## **PARKER ESTATES SUBDIVISION**

APPLICATION NUMBER 8 DATE May 21, 2015

REQUEST Subdivision

# DETAIL SITE PLAN

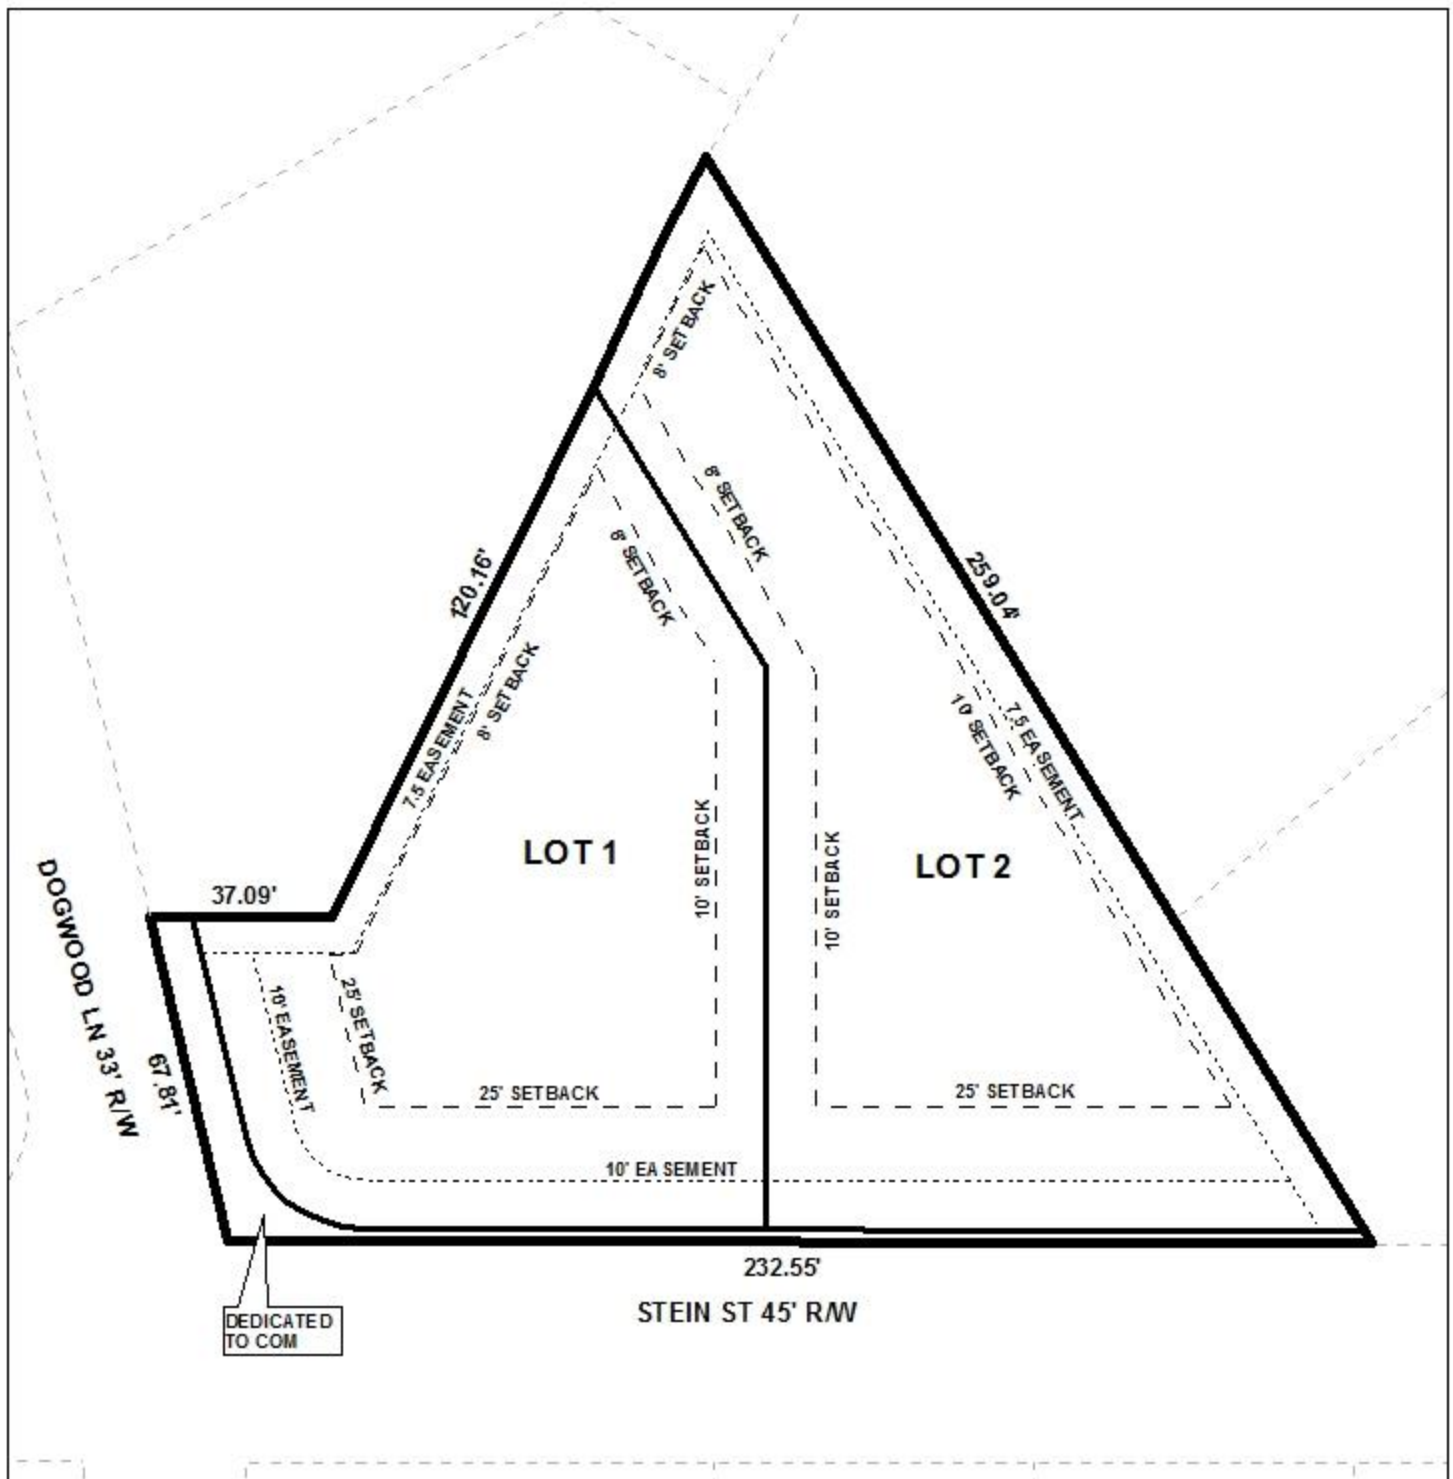
The site has frontage onto two streets: Stein Avenue and Dogwood Lane. Both streets are considered minor streets, and both have curb-and-gutter. As minor streets with curb-and-gutter, both Stein Avenue and Dogwood Lane should have right-of-ways of 50'. Stein Avenue is illustrated as having an existing right-of-way of 45' and Dogwood Lane is illustrated as having an existing right-of-way of 33', making dedications to provide 25' from the centerline of both roads necessary. Furthermore, dedication of the corner radii at Stein Avenue and Dogwood Lane per Section V.D.6. of the Subdivision Regulations should be required.

The 25-foot minimum building setback line, required in Section V.D.9., is shown on the preliminary plat, and should be retained on the Final Plat, if approved, revised to reflect any required dedication. The preliminary plat illustrates existing 7.5' drainage and utility easements as well as a 10' utility easement. These should remain on the Final Plat, if approved, along with a note stating that no structures are to be erected in any easement.

The applicant requests that the proposed Lot 1 be allowed to maintain two existing curb cuts, one to Dogwood Lane and one to Stein Avenue; and that the proposed Lot 2 be allowed to maintain an existing curb cut to Stein Avenue. If approved, a note should be placed on the Final Plat, stating that each lot is limited to the existing curb cuts, with the size, location and design to be approved by Traffic Engineering and conform to AASHTO standards.

The preliminary plat and vicinity map submitted incorrectly label Stein Avenue as "Stein Street". If approved, the Final Plat should correctly identify Stein Avenue.

- 1) dedication to provide 25' from the centerline of Stein Avenue;
- 2) dedication to provide 25' from the centerline of Dogwood Lane;
- 3) dedication of the corner radii at Stein Avenue and Dogwood Lane per Section V.D.6. of the Subdivision Regulations;
- 4) revision of the 25' minimum building setback line to reflect dedication;
- 5) change the "Stein Street" to "Stein Avenue" on the Final plat and vicinity map;

- 6) placement of a note on the Final Plat stating that the site is limited to the existing curb cuts with any changes to the size, design or location of the curb-cuts to be coordinated with Traffic Engineering;

- 7) retention of the lot sizes in square feet and acres, or placement of a table on the plat with the same information, revised to reflect dedication;
